# 8th Edition(2023) Florida Building Code

Proposed Code Modifications

## ROOFING

# TAC: Roofing

Figure RE1.1

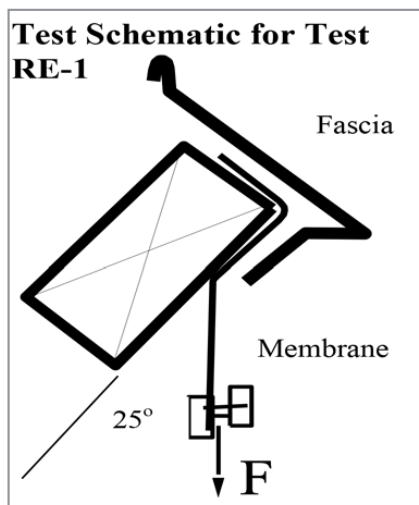
The description of the apparatus is general in nature. Any equipment capable of performing the test procedure within the allowed tolerances shall be permitted. A schematic drawing of this apparatus is shown in Figure RE1.1. The test apparatus shall be constructed so that the performance of individual components are unaffected by end constraints on the test sample. Load shall be applied and measured with calibrated load cells, each accurate to within  $\pm 3\%$  of full scale load cell values. Calibration shall be performed annually (minimum) and should be performed and recorded at 5%, 25%, 50%, and 75% of the expected maximum test values.

Figure RE1.2

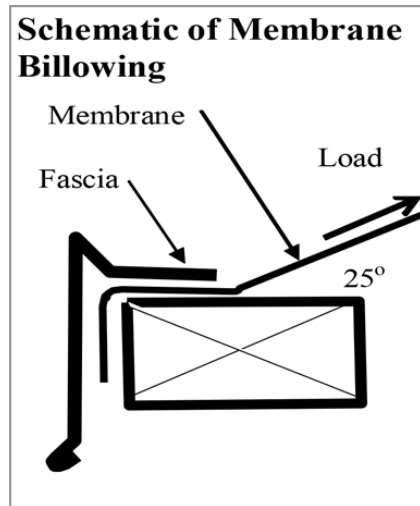
To test the roof edge system's ability to restrain a membrane force, uniform tension shall be applied along the length of the membrane used in the test. The minimum length of the membrane and roof edge system shall be such that the roof edge system sample contains three (3) attachment fasteners at the design fastener spacing, or is 3 ft 0 in (915 mm) in length, whichever is greater. The roof edge system shall be constructed and mounted on the base of a tensile testing device so the membrane is pulled at a 25° angle to the roof deck to simulate a billowing membrane (see Figure RE1.2).

Figure RE-3.1 RE-3 Test—Face Leg Pull

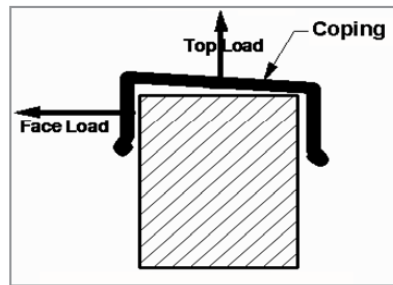
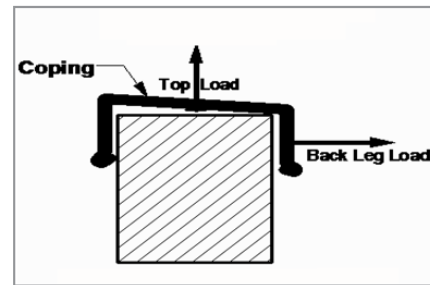
Both face and back legs shall be tested in this manner using separate test samples. Thus, one sample to test the face while loading the top (Figure RE3.1), and the other to test the back leg while loading the top (Figure RE3.2).

Figure RE1.3—Mechanically Attached Roof Forces

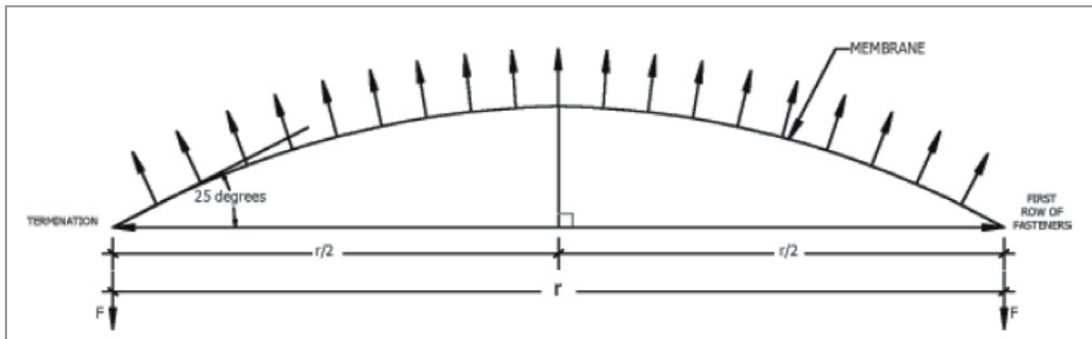
Referring to Figure RE1.3 for a mechanically attached system, the loading depends upon the distance,  $r$ , of the first row of *fasteners* to the edge termination. The overall shape of the *membrane* is based upon previous tests indicating that the *membrane* deformation can be well approximated by a 25 degree angle<sup>4,5</sup>. Figure RE1.4 shows a closer look at the *membrane* forces.
